Item 7, Sidewalk Café at 815 O Street, Pepperberg Building
Also see attachments.

Re: Sidewalk Café for Sweep Left
815 O Street

PROPOSED SIDEWALK CAFE

SIDE WALK CAFE PLAN

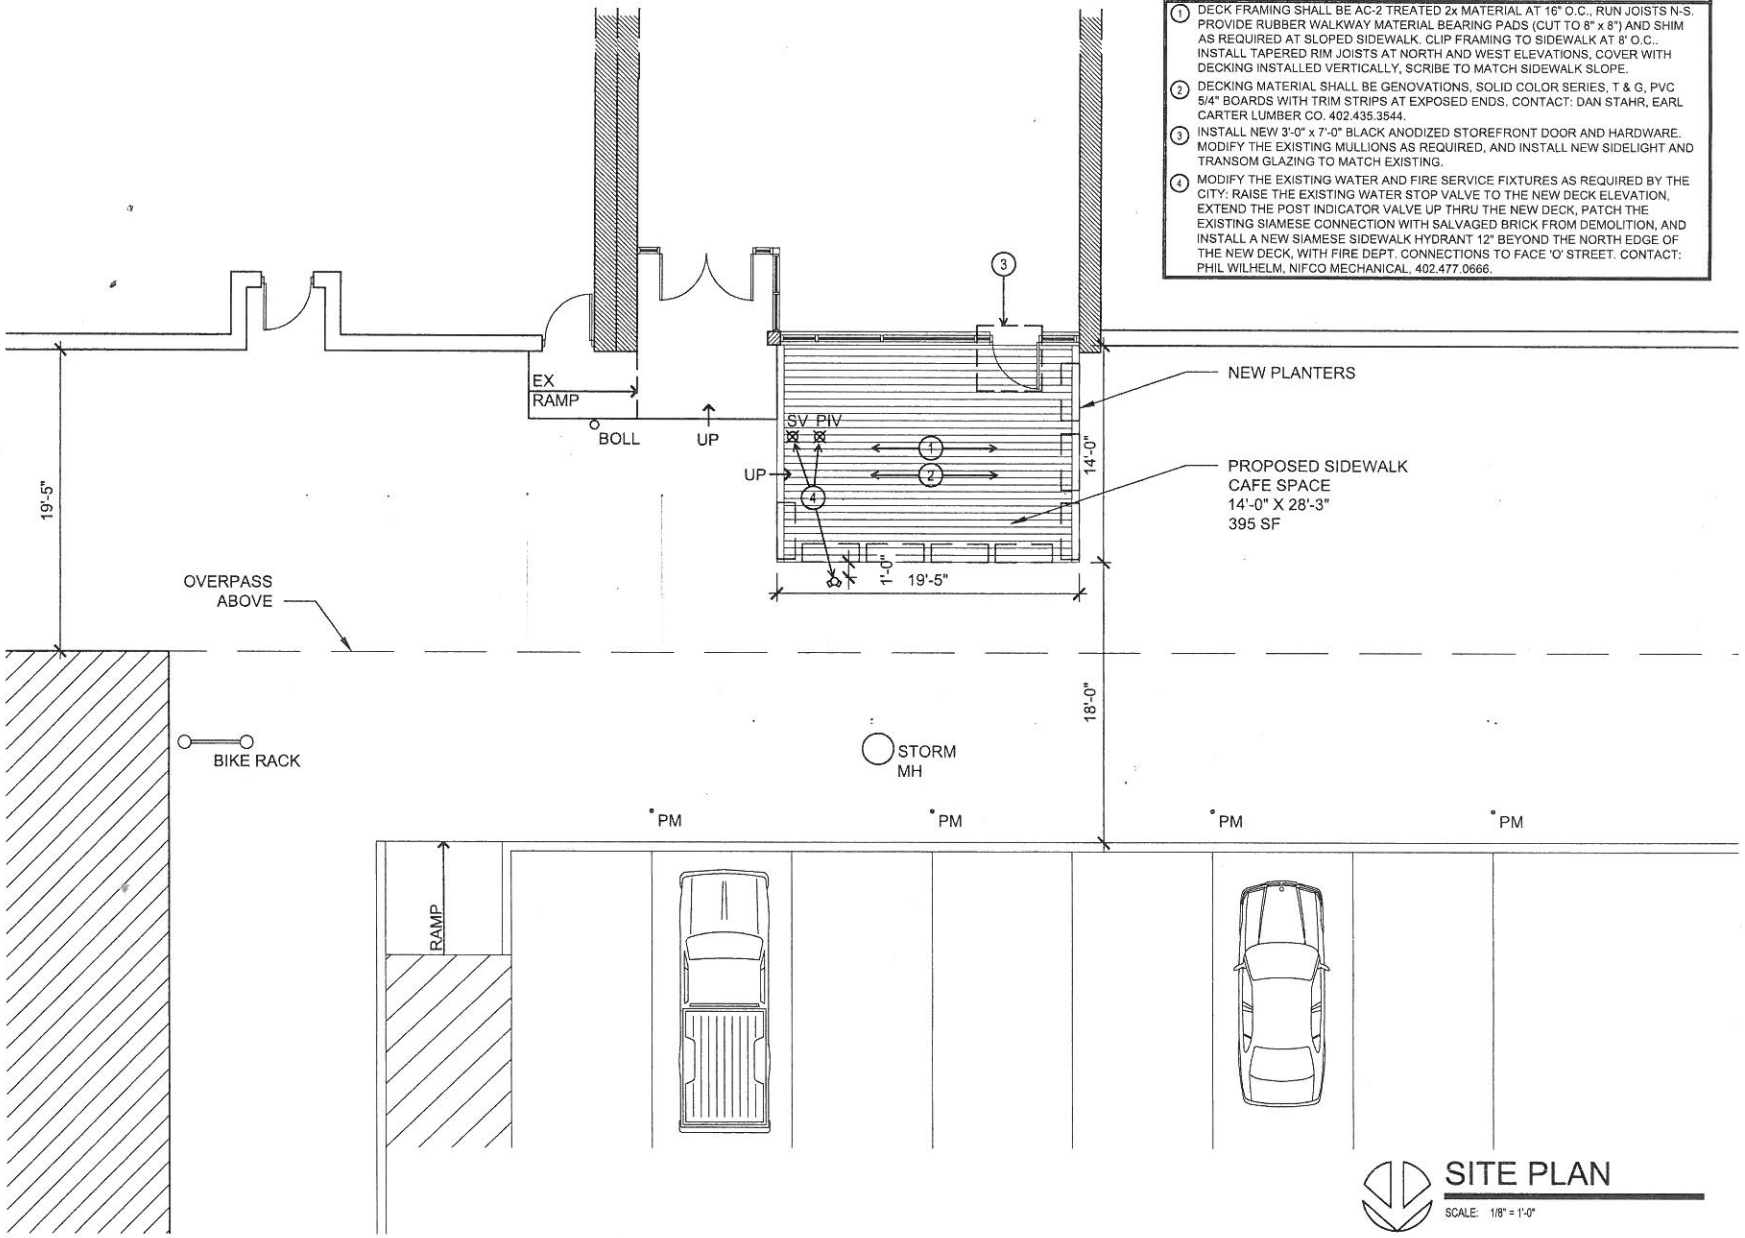
The sidewalk café would consist of a deck/platform 19'5" wide by 14' deep. 18 feet of sidewalk width would remain between the deck and the curb of the parking area under the Harris Overpass. Because the sidewalk slopes down about a foot from east-west across the length of the storefront, a platform of gray, "commercial-grade," PVC tongue & groove decking is proposed, enclosed by a black steel railing with built-in, irrigated planter boxes. Each planter box would also support a tempered-glass shield on the outer side, serving as windbreaks.
A new doorway through the aluminum storefront is also proposed, for server access to the sidewalk café. The door, sidelight and transom would match the storefront system, and would require removal of an area of brick to match the door sill to the deck level. This pressed brick should be retained and stored on-site.

The sidewalk café utilizes elements similar to other approved sidewalk cafes in the district. Vincenzo's at 808 P occupies a similarly sloped sidewalk and utilizes a deck for leveling. Vincenzo's also utilizes a separate door through the storefront for accessing the sidewalk café. Generally storefront modifications have been acceptable provided the broad design characteristics of the storefront have been retained, as in this case. In addition, storefronts historically have been somewhat flexible features of facades, adapting to changing uses.

Several approved Haymarket cafes feature planters, flower pots, or flower boxes. The glass shields are a new feature but appear to be minimally intrusive and may enhance the café experience in a challenging urban location.

Therefore, staff recommends a finding that the proposal is consistent with the character of the Haymarket district and further, recommends approval of a certificate of appropriateness.
